CORPS OF ENGINEERS

2-1-50	CORRECTED DWG. NO. — ADDENDUM NO. 2
REVISION	DATE
DESCRIPTION	
CORPS OF ENGINEERS U. S. ARMY OFFICE OF THE DISTRICT ENGINEER HUNTINGTON, W. VA.	
DRAWN BY: E.S.W.	TUSCARAWAS RIVER LOCAL PROTECTION PROJECT MASSILLON, OHIO SIPPO CREEK PUMP STATION LOCATION PLAN & PROFILES
TRACED BY: L.L.L.	
CHECKED BY: M.W.W.	
APPROVED BY: J. E. Johnson	
DATE: DEC. 1949	DATE: DEC. 1949
SCALE: AS SHOWN	SPEC. NO.
DRAWING NUMBER 0271-PM-51.3/1	SHEET 25 OF 42

EL. 928.0 TO EL. 935.5

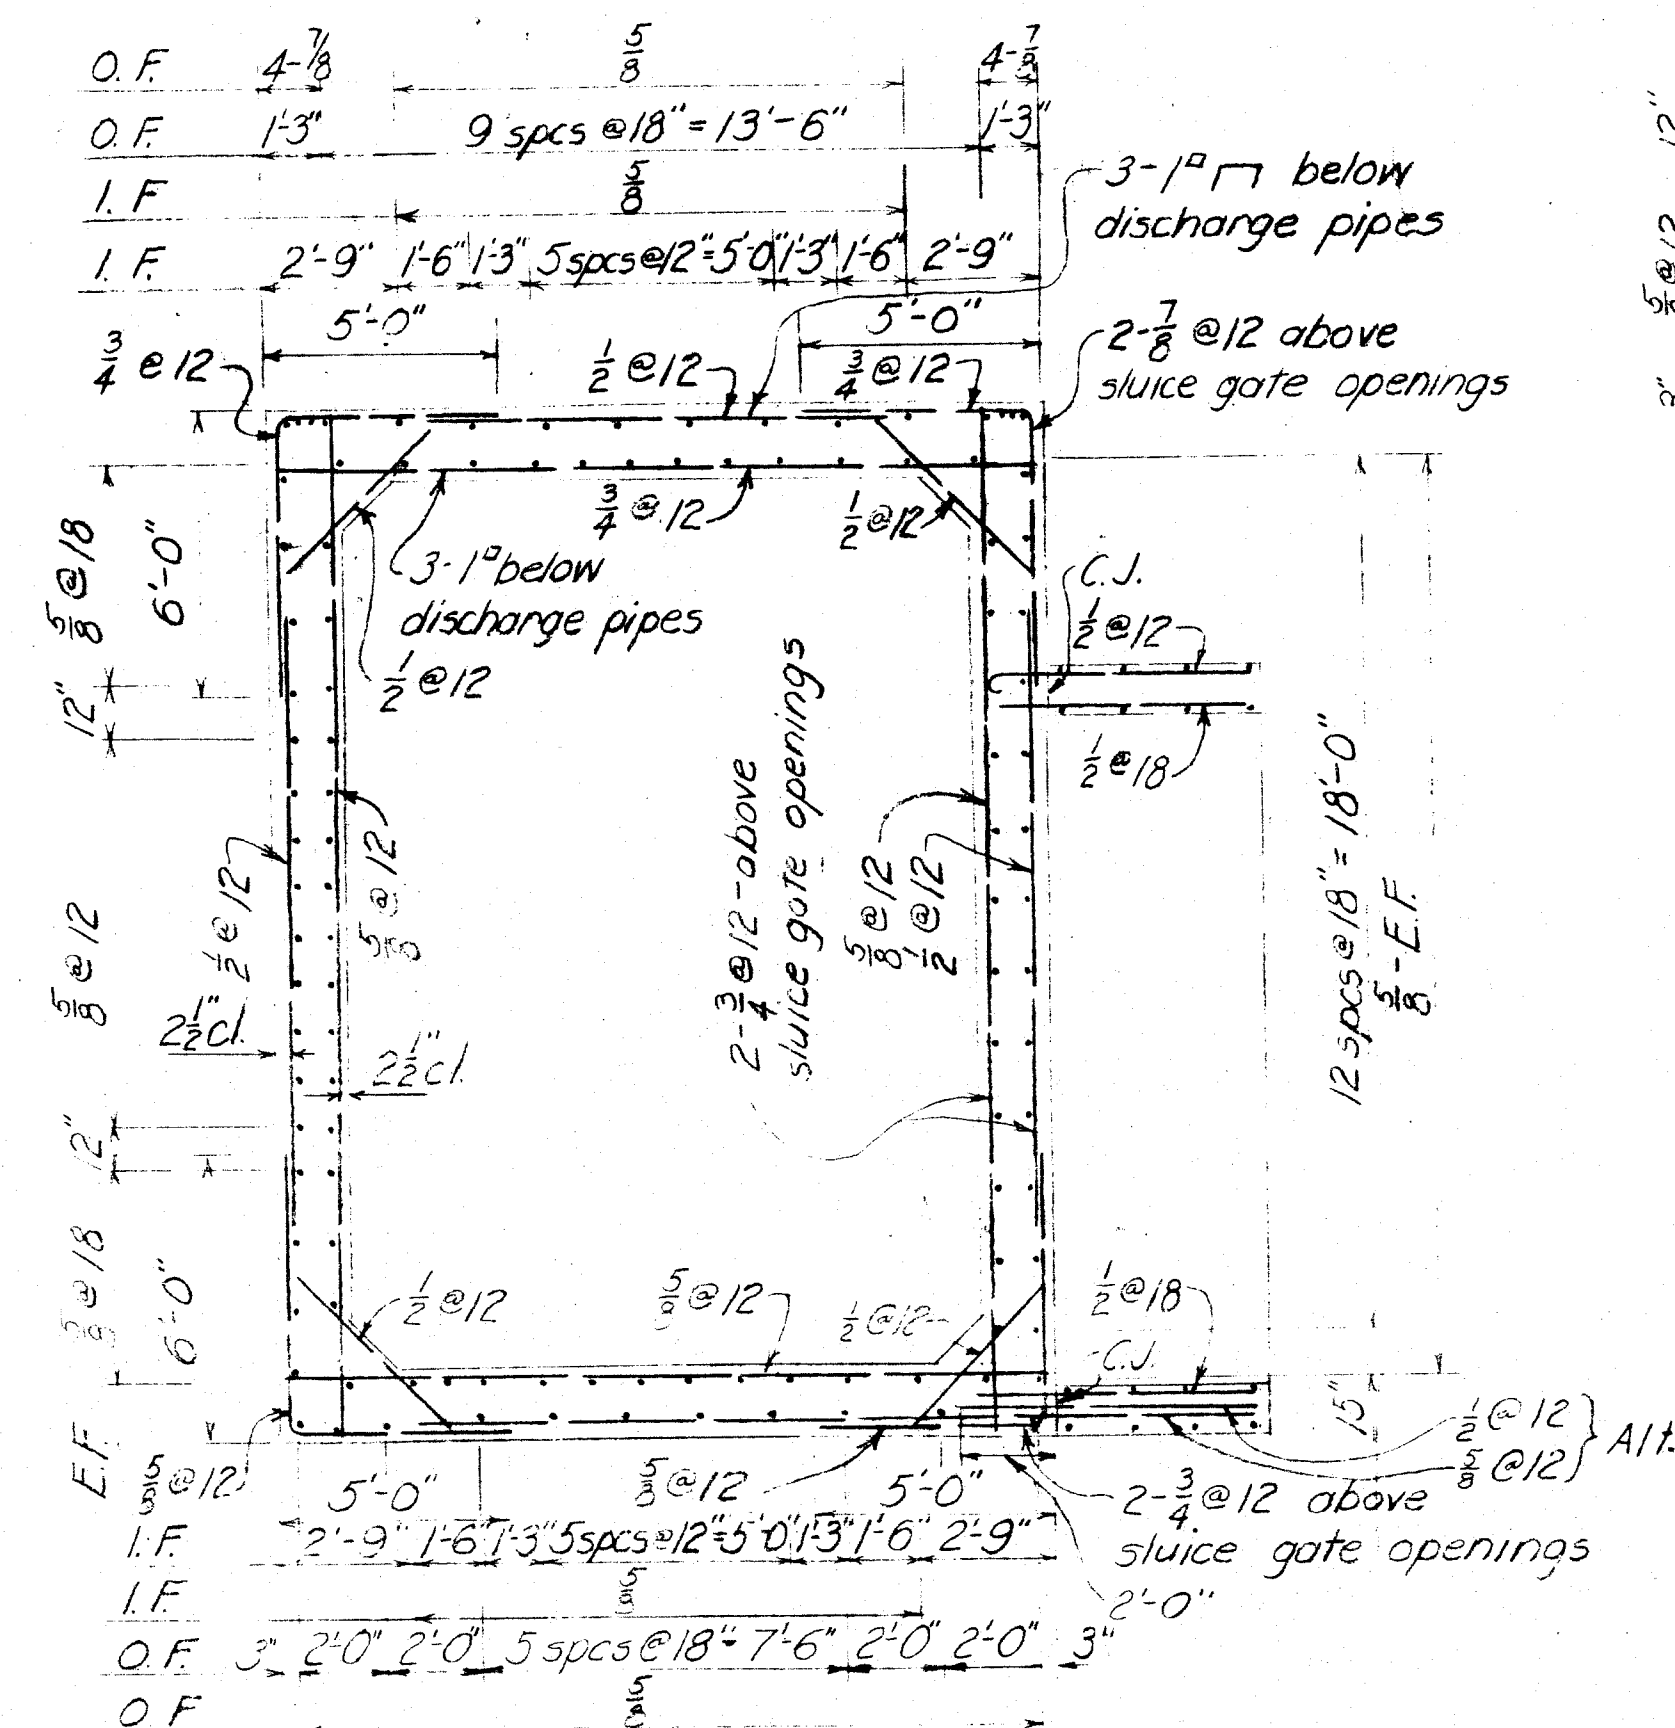
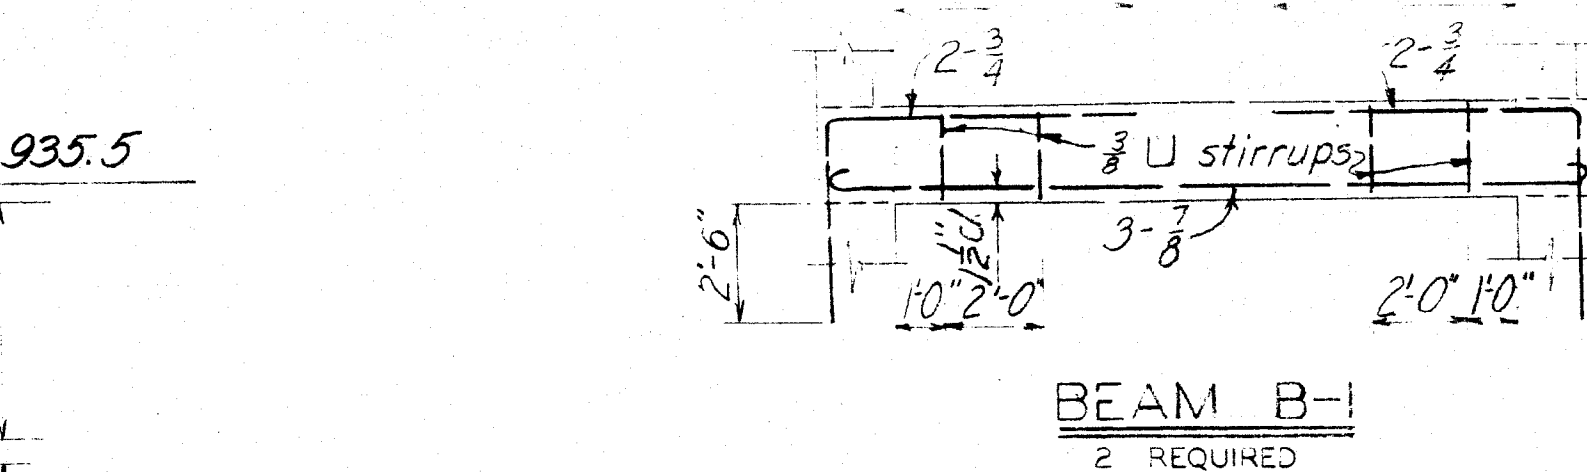
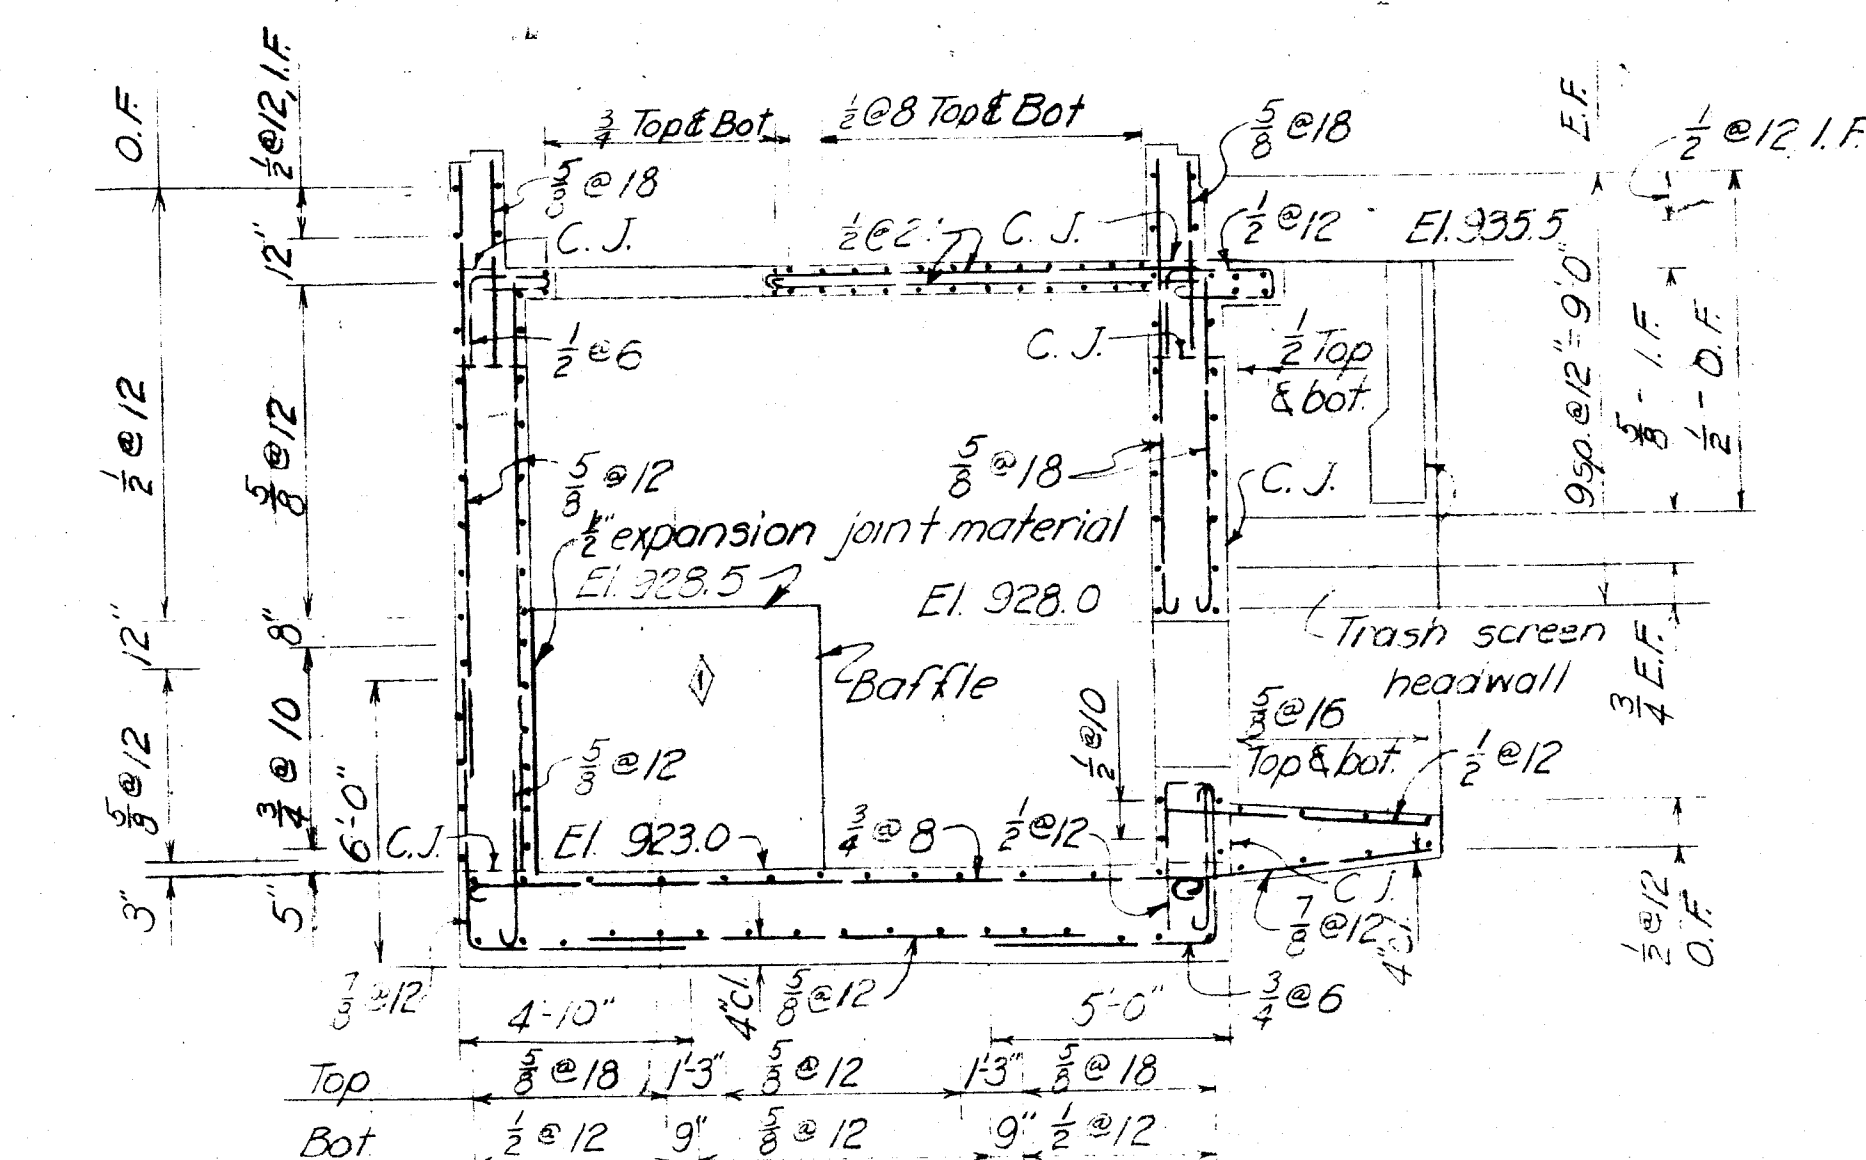
2-1-50	DELETED HOOKS AT HAUNCHED CORNERS-ADDENDUM NO. 2	K.S.B.
1-9-50	ADDED BAFFLES-ADDENDUM NO. 1	K.S.B.
REVISION	DATE	DESCRIPTION
CORPS OF ENGINEERS		
OFFICE OF THE DISTRICT ENGINEER		
HUNTINGTON, W. VA.		
TUSCARAWAS RIVER		
LOCAL PROTECTION PROJECT		
MASSILLON, OHIO		
SIPO CREEK PUMP STATION		
REINFORCING DETAILS		
DRAWN BY:	E.S.W.	
TRACED BY:	F.W.L.	
CHECKED BY:	H.D.G.-M.W.W.	
SUBMITTED BY:	Mr. [Signature]	
APPROVED:	Mr. [Signature]	
CHIEF ENGR. ASST.		
APPROVED FOR:		
DATE:		
DATE:	DEC. 1949	
SCALE:	1/4" = 1'-0"	
DRAWING NUMBER	0271-PM-51.3/4	
SHEET	20 OF 42
